National Committee on Uniform Traffic Control Devices

National Committee on Uniform Traffic Control Devices (NCUTCD) Recommended Changes to Proposed Text for 11th Edition of the MUTCD Docket Number: FHWA-2020-0001

16 17 Federal Register Item Numbers: 29-45 (see listing below) NPA MUTCD Section Numbers: Sections 2A.01 - 2A.22

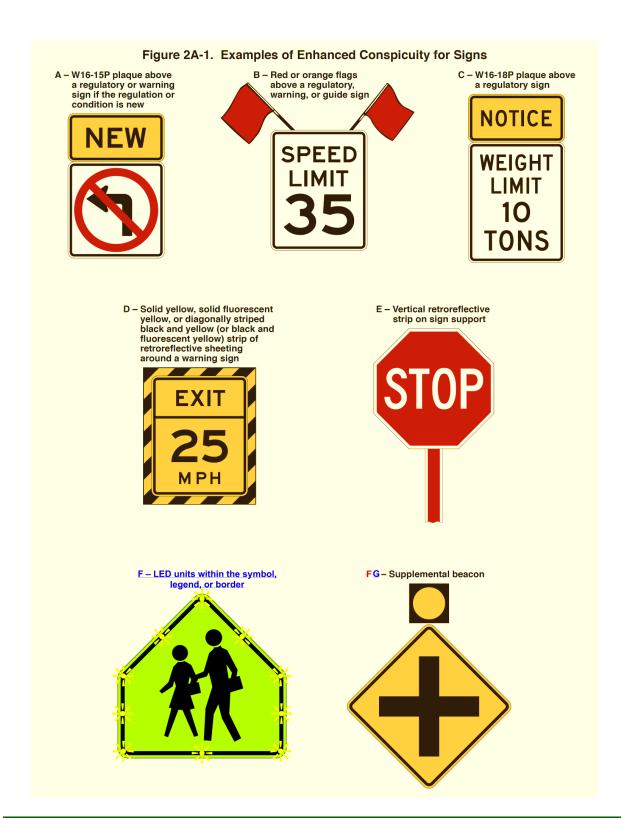
721 722 NCUTCD generally agrees with Figure 2A-1, but recommends the figure be modified to include a School Warning sign with LEDs in the border and reordering of items in the figure.

Figure 2A-4. Relative Locations of Regulatory, Warning, and Guide Signs on an Intersection Approach

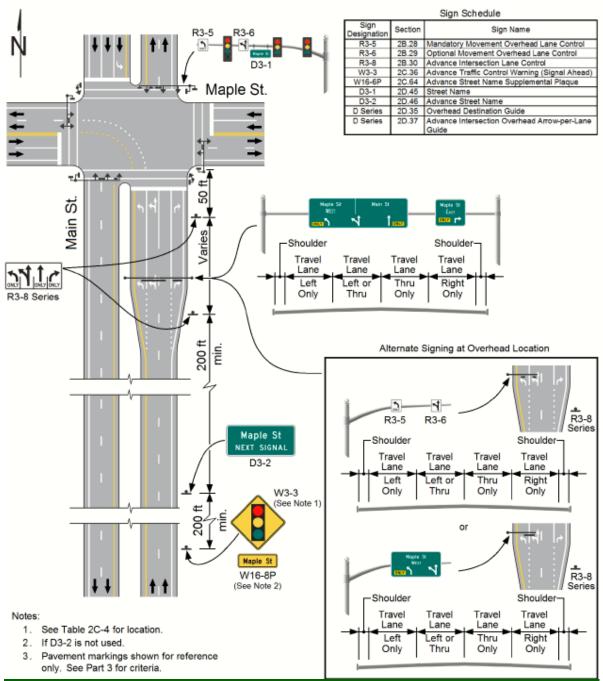
NCUTCD generally agrees with Figure 2A-4 sheet 2 of 4 as presented in the NPA except the

Figure 2A-4. Relative Locations of Regulatory, Warning, and Guide Signs on an Intersection Approach

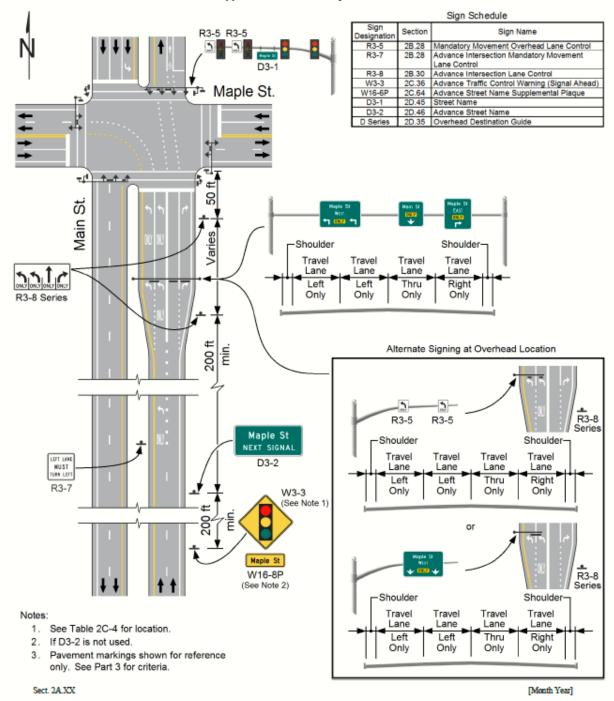
NCUTCD generally agrees with Figure 2A-4 sheet 3 of 4 except:

- Change the arrows in the Maple St sign in the alternate signing at overhead location detail above to be left turn arrows, not down arrows.
- In the sign schedule above, the W16-6P should be W16-8P.
